**APPENDIX D**  
**VALUE ENGINEERING STUDY**

**FINAL REPORT**  
**VALUE ENGINEERING STUDY**

**CDOT – Region 5**  
**US 550 Environmental Assessment**

**December 2003**

4 01-008

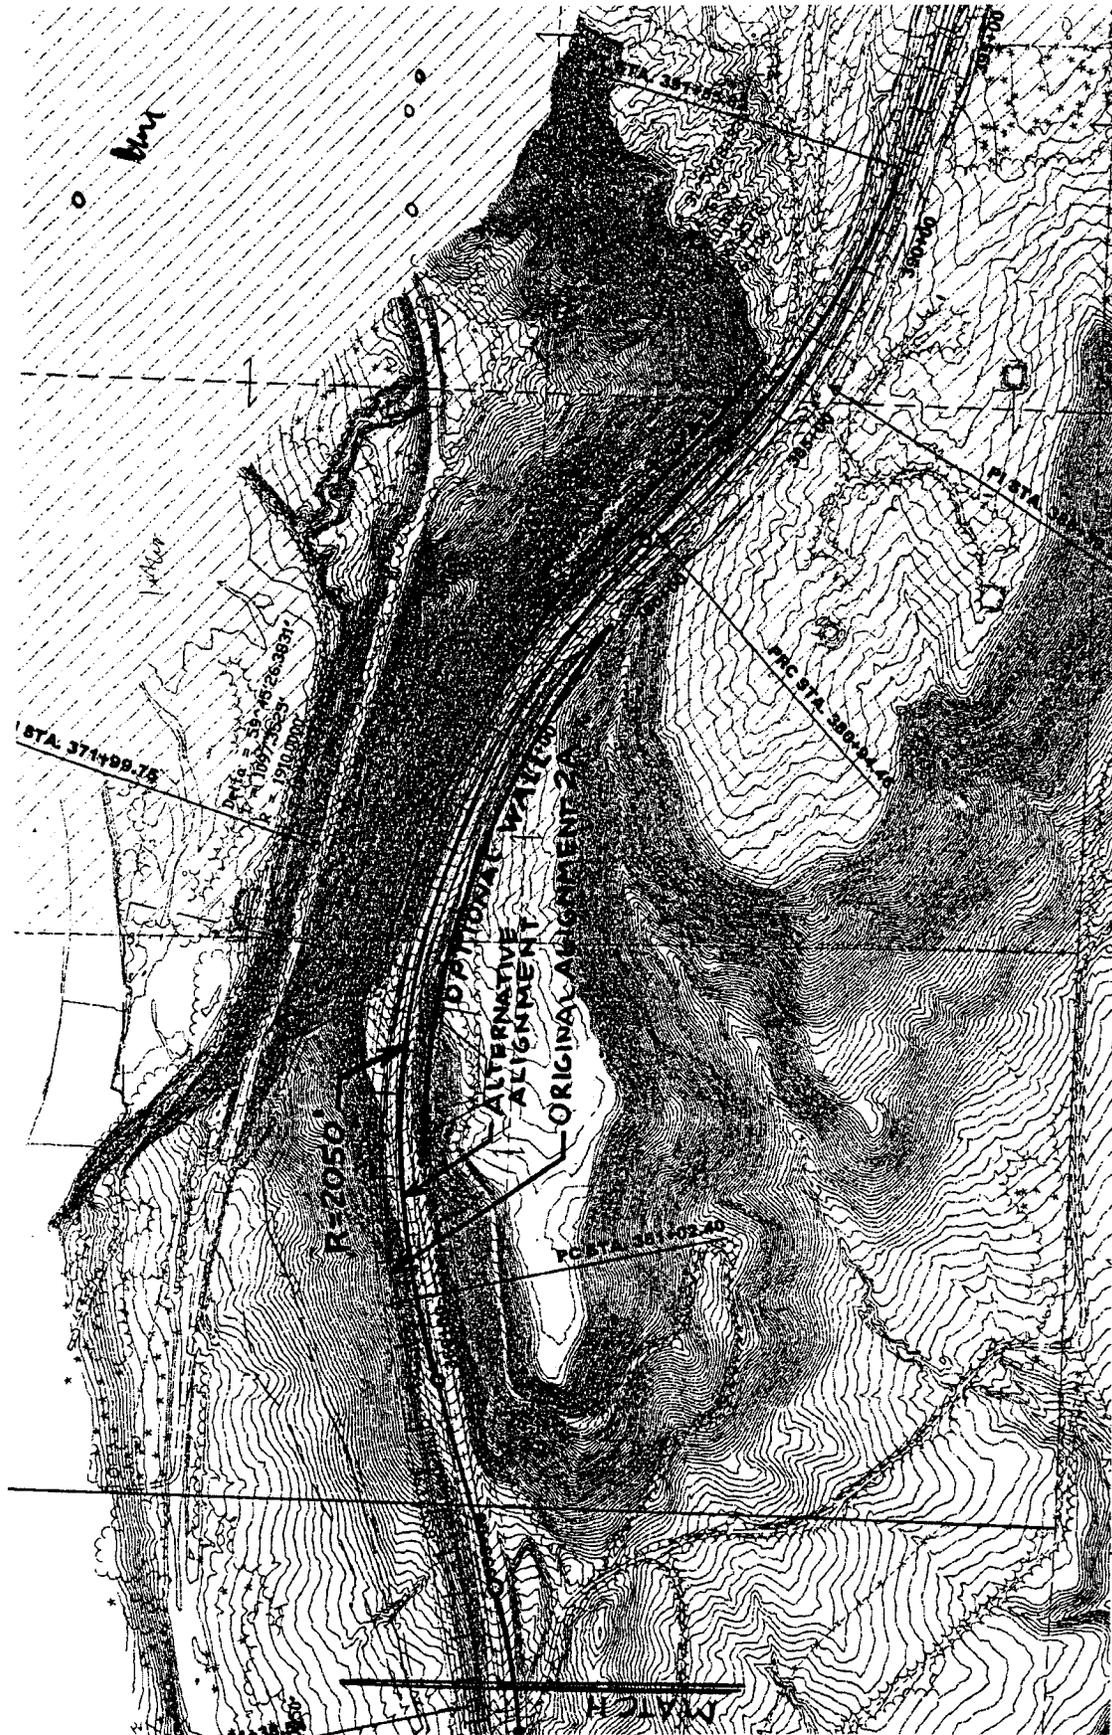
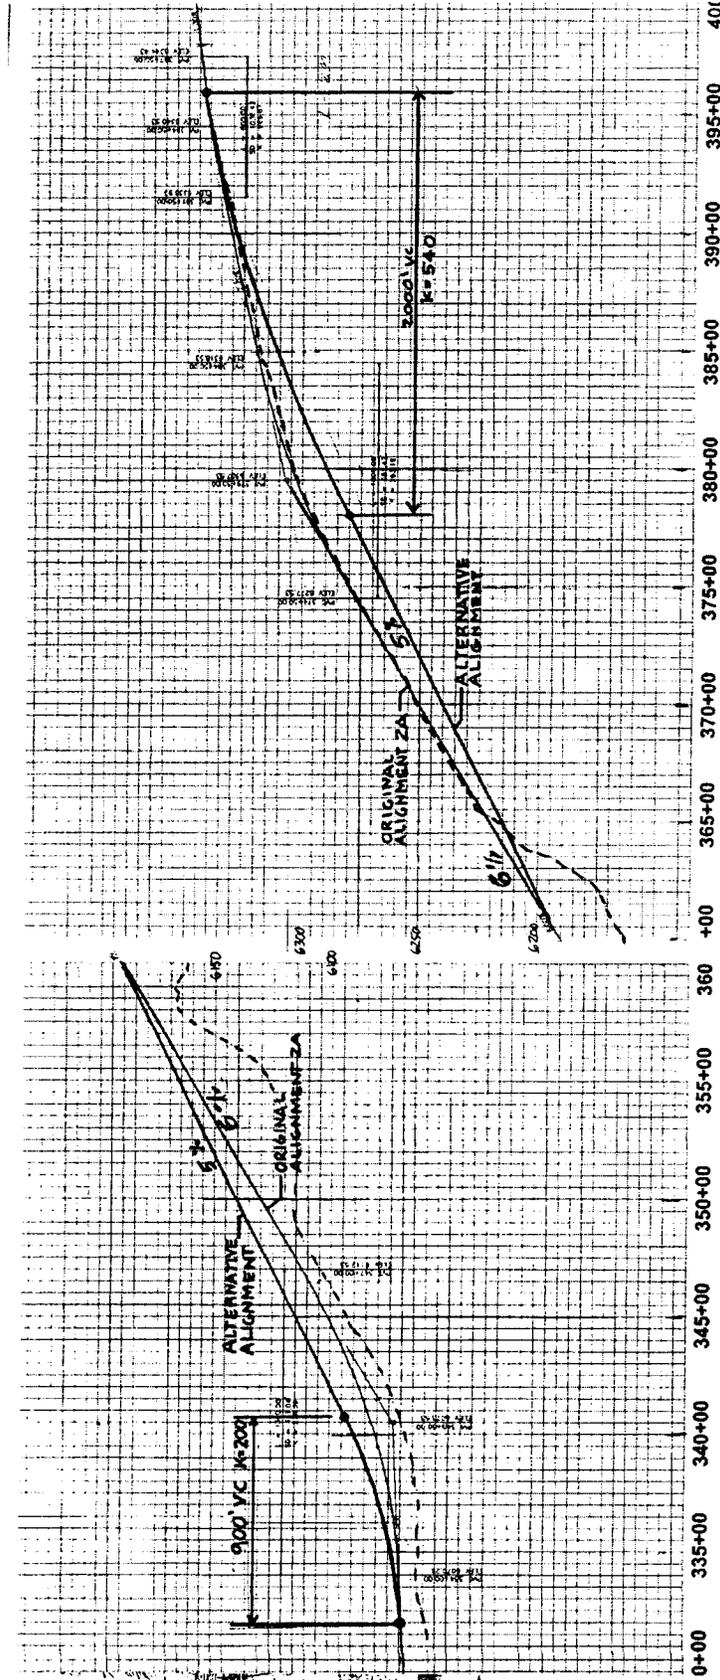
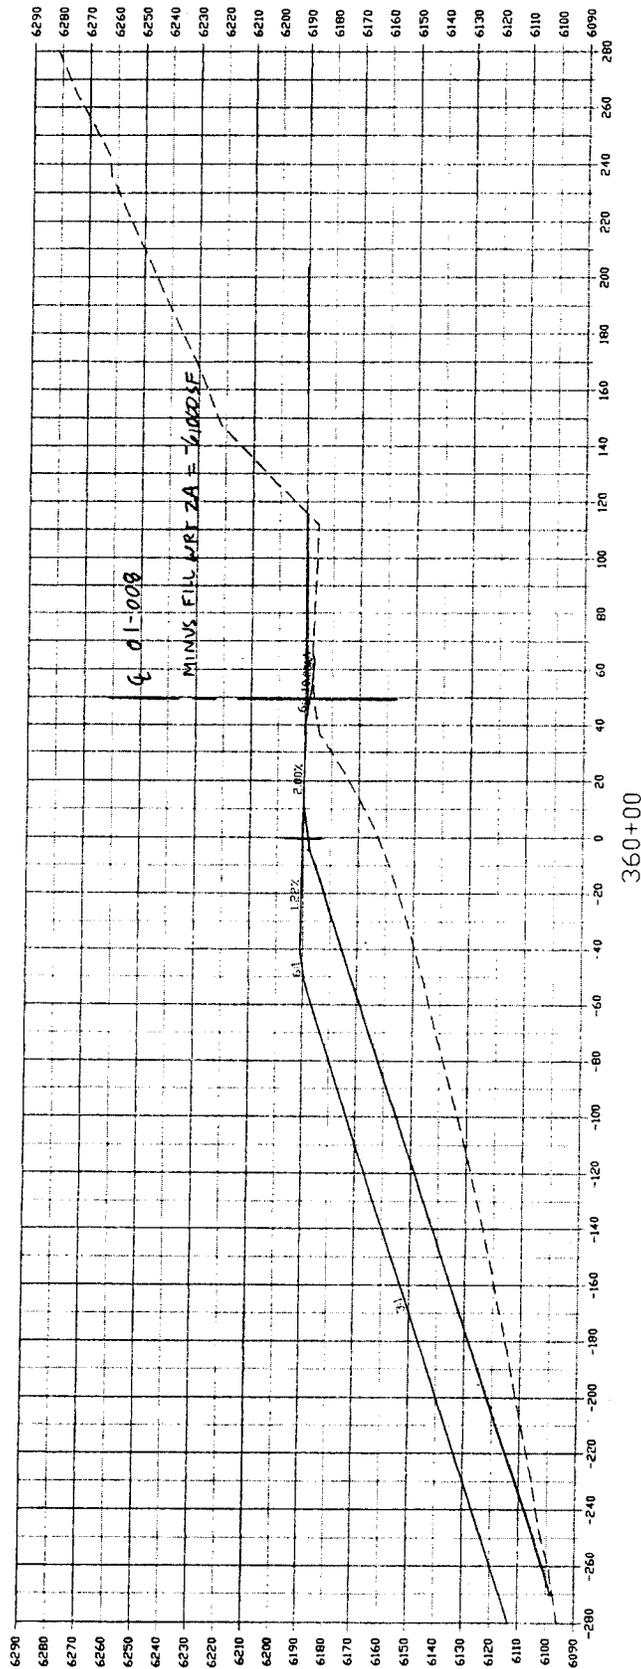
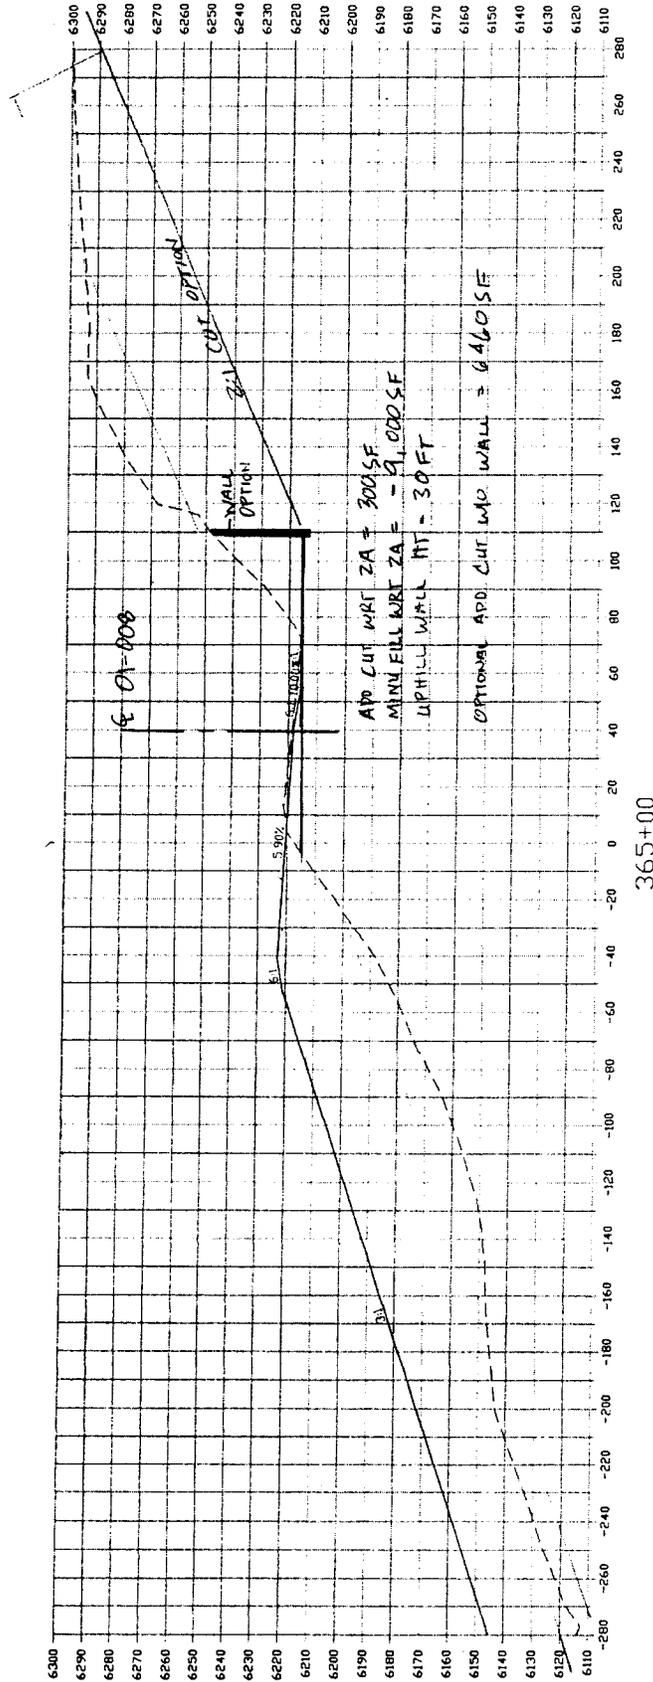
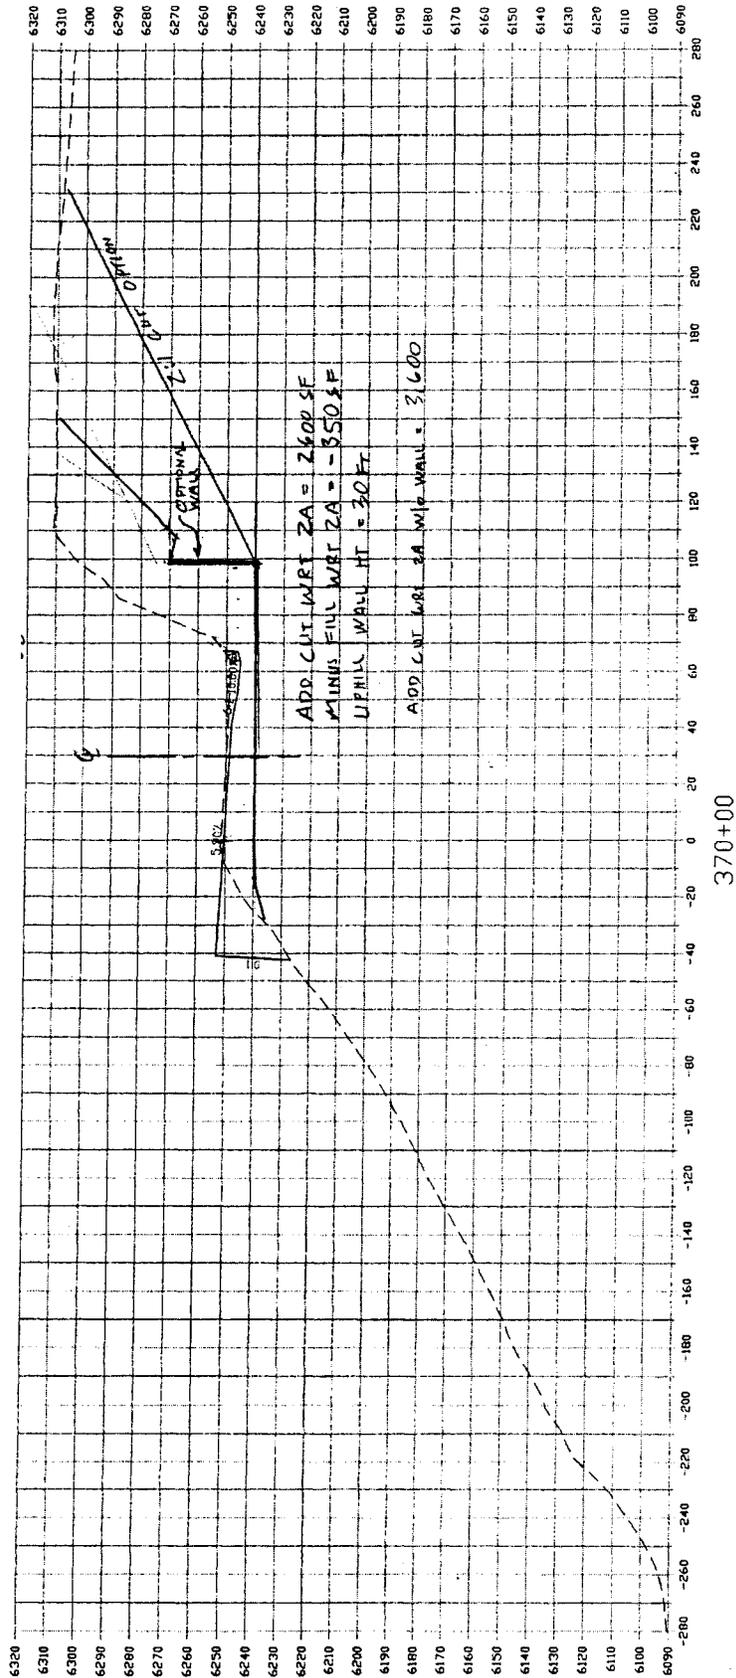
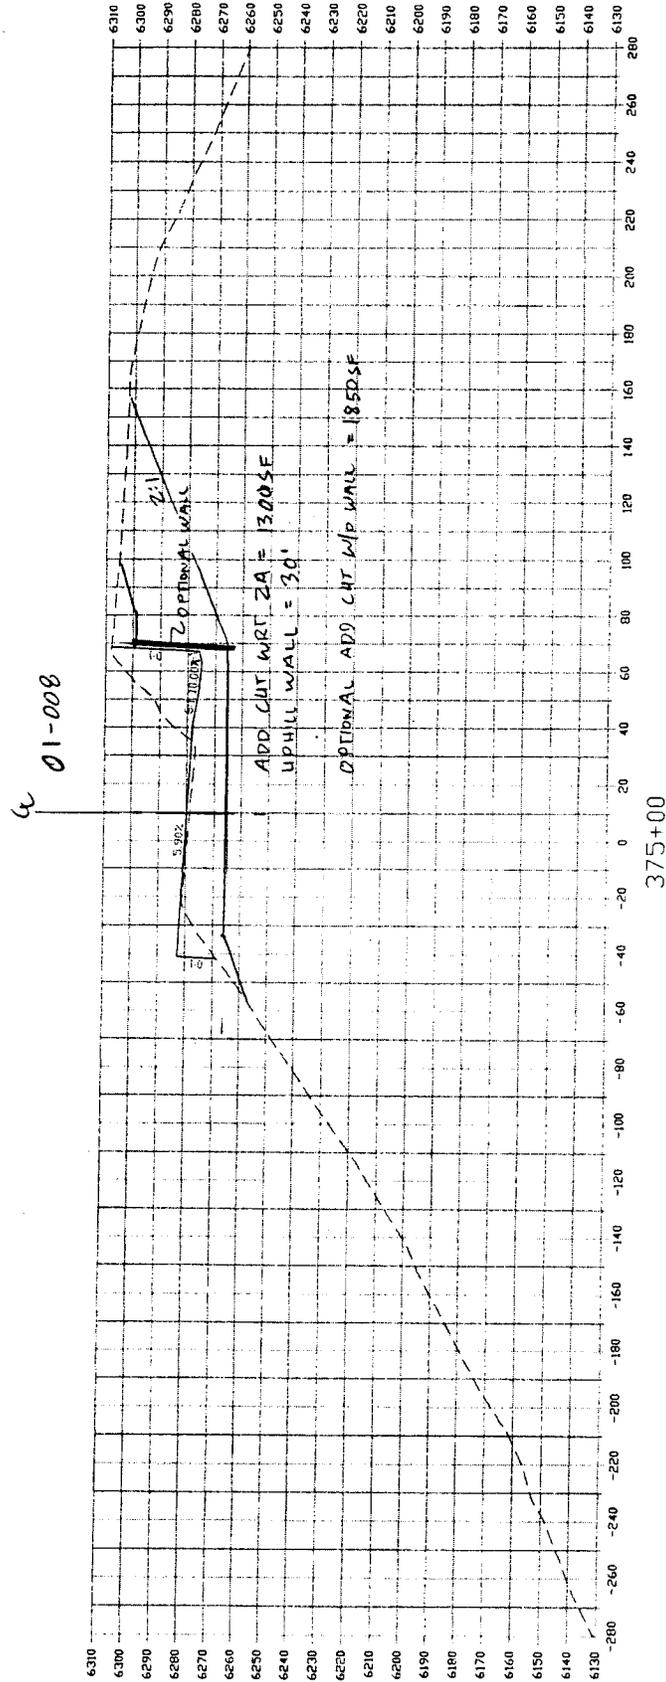
01-008  
ADD CUT WRT ZA = 1260 SF  
DOWNHILL WALL = 12'

SIGHT DISTANCE ACROSS INSIDE MEDIAN BARRIERS  
(USING CURRENT AASHTO STANDARDS)

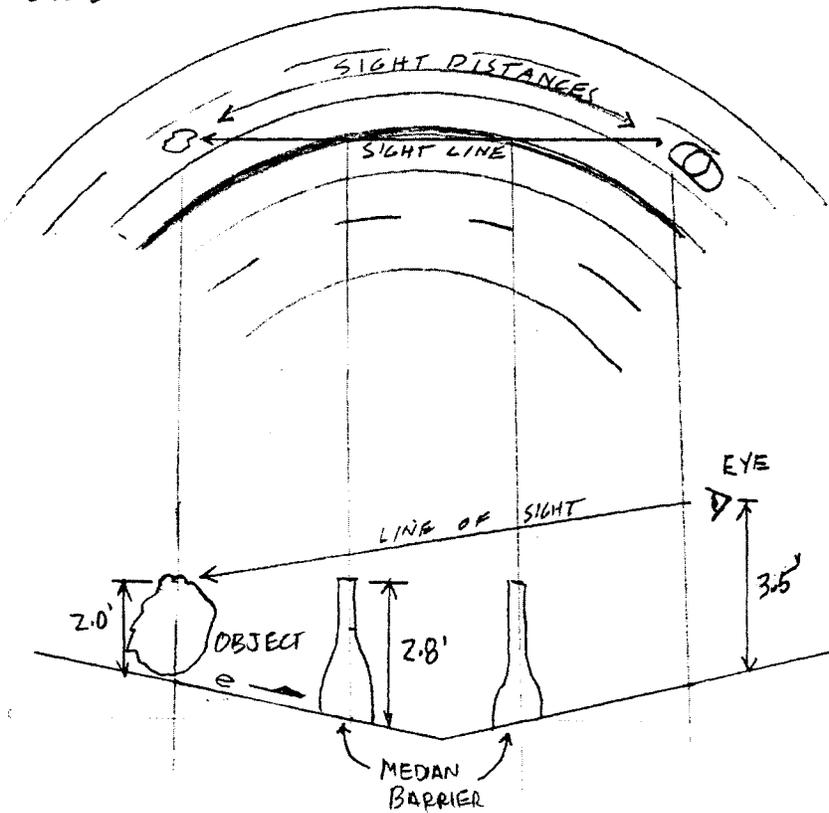
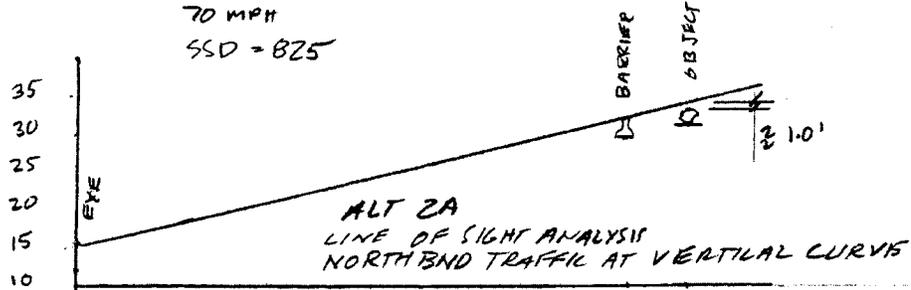
Perform a 3D graphical analysis of sight distances to increase design speeds at Bondad Hill, using current AASHTO standards.

<u>References</u>
Height of eye:	3.5'	AASHTO2001p271
Height of object:	2.0'	
Stopping Sight Distances:	70mph 825'	AASHTO2001Ex3-1
	65mph 728'	
adjusted for 6 % downgrade	60mph 638'	
	55mph 553'	
	50mph 474'	
	45mph 400'	
Barrier Ht:	34"=2.83' for CDOT guardrail type 7	CDOT Std. M-606-13

#### Scheme 2 – Additional Downhill Wall Sta 354+00 to 366+00

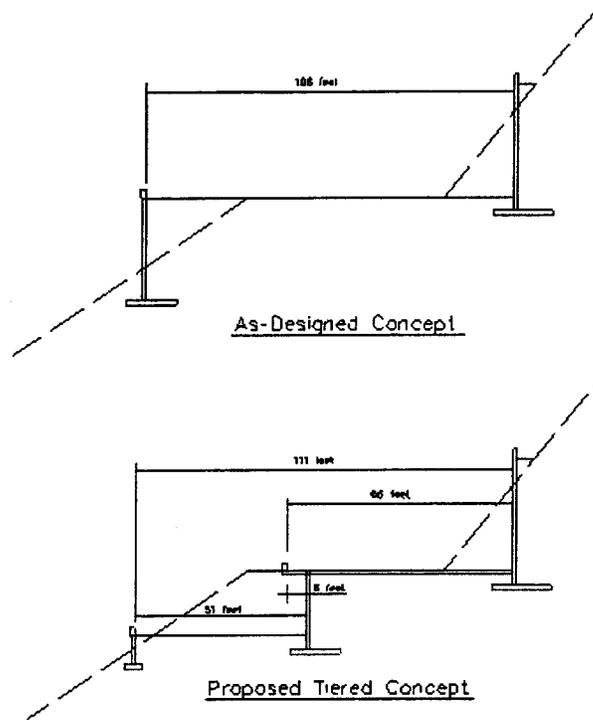
It appeared during review of the cross sections for Section 2A, that significant fills are required between the stations noted. In addition, due to the existing side slope grades, and the proposed fill slope, a long "catch up" distance was required. The side slopes in this area appear to require up to 300 feet before they catch. This may have significant environmental impacts (removal of all existing trees and vegetation in fill section), which were not evaluated as part of this proposal.

Using the cross sections, approximate fill end areas and wall heights were determined (scaled). A spreadsheet was developed to evaluate the cost (see attached).
